PRIVATE PLAN CHANGE 94
ADDENDUM HEARING REPORT
WAIRAKA PRECINCT IN CARRINGTON ROAD,
MT ALBERT
MINISTRY OF HOUSING AND URBAN
DEVELOPMENT – HANNAH MCGREGOR

Addendum Section 42A Hearing Report for Proposed Private Plan Change 94: Wairaka Precinct to the Auckland Unitary Plan (Operative in part)

- (9A) Occupation of development does not occur in advance of the availability of water supply and wastewater services for that development.
- (10) An integrated urban environment is created, which:

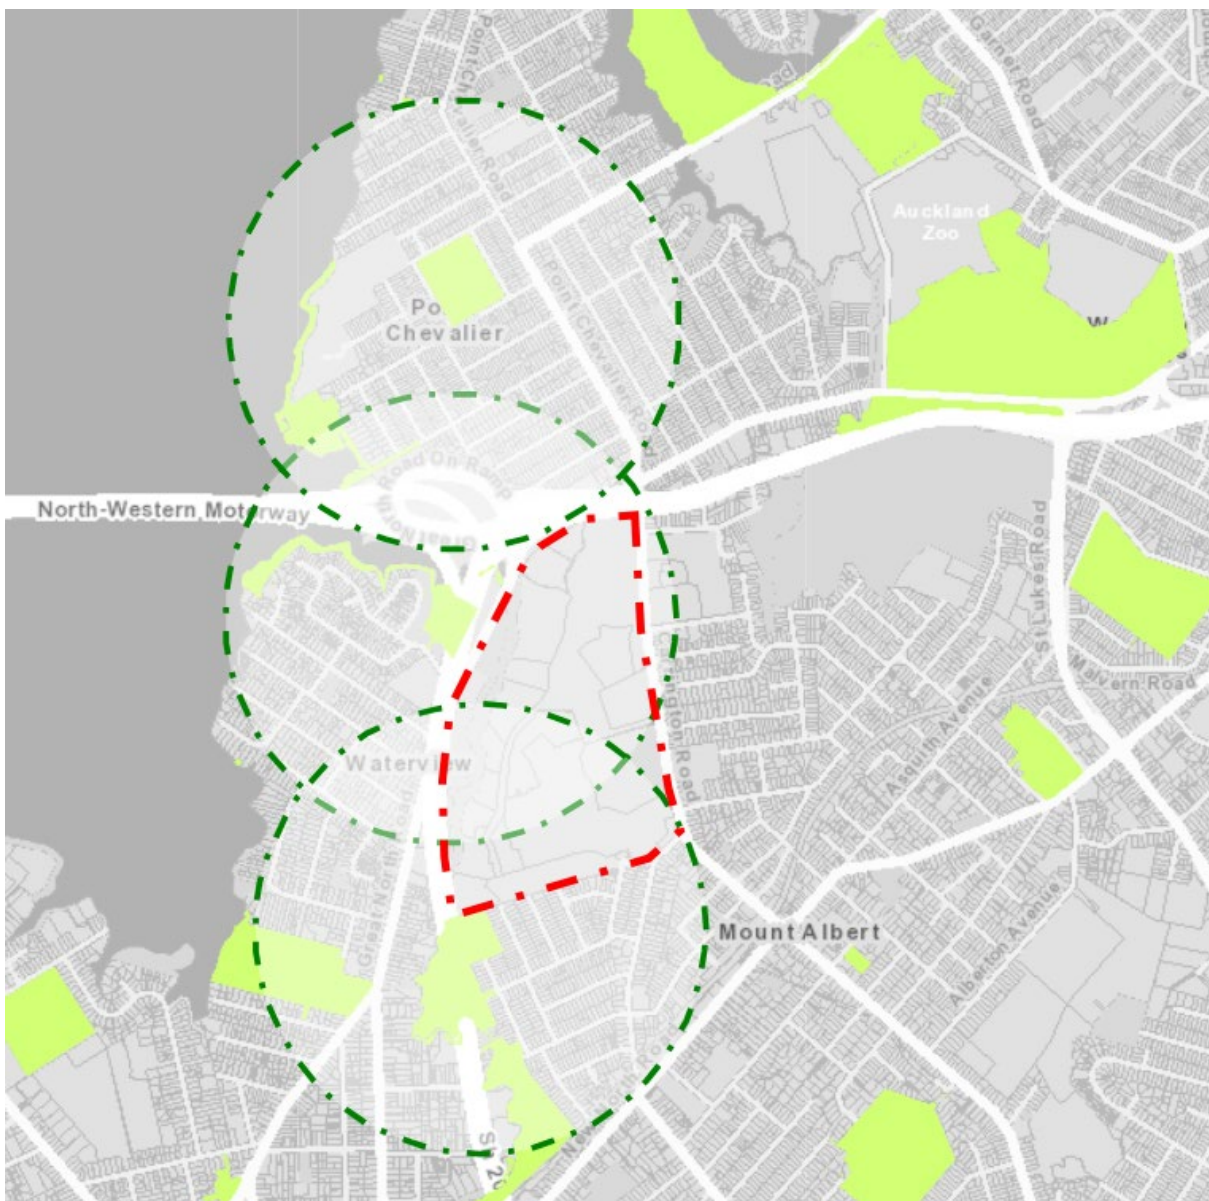
- (b) Facilitates transport choices by providing for pedestrians, cyclists, public transport facilities, and vehicles.
- (9) Development of any roads connecting to the existing roading network to the south of the Pprecinct must be subject to specific resource consent processes to ensure that any private or public road connections must:

- (a) Incorporates high quality built form and ~~urban~~ design including a variety of built form typologies;
 - (b) Recognises, protects and enhances the natural and physical environmental attributes of ~~Wairaka the precinct in its planning and development of the Precinct;~~
